Site: Linwood Hiding  
 ID: 1AD 9801 51237  
 State: Ia.  
 Other: \_\_\_\_\_

RE: Contaminated well at Buffalo, Iowa

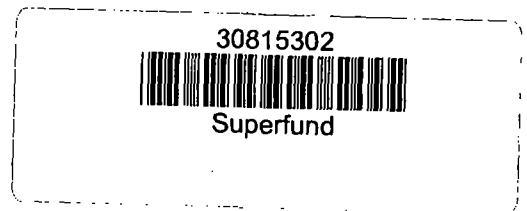
I visited with Kevin Powell and discussed the alternatives with him. In addition, I told him I would write you and explain the alternatives to you and make a recommendation relative to correcting the situation.

After visiting your facility I stopped in at the Geological Survey in Iowa City and discussed the situation with Drs. Jean Prior and Don Gordon. Dr. Gordon further recommended, in addition to replacing the iron pipe with PVC as I had recommended to you previously, that before doing anything permanent you should drop a 2" PVC pipe down to the aquifer (240 feet), thoroughly flush, and analyze samples. If the water is safe, then replace the 6" and 4" iron pipe with PVC and grout in. This should eliminate the source of the contamination problem. However, these actions should be taken very quickly, as any significant delay could result in aquifer contamination. This would adversely affect nearby wells not now contaminated.
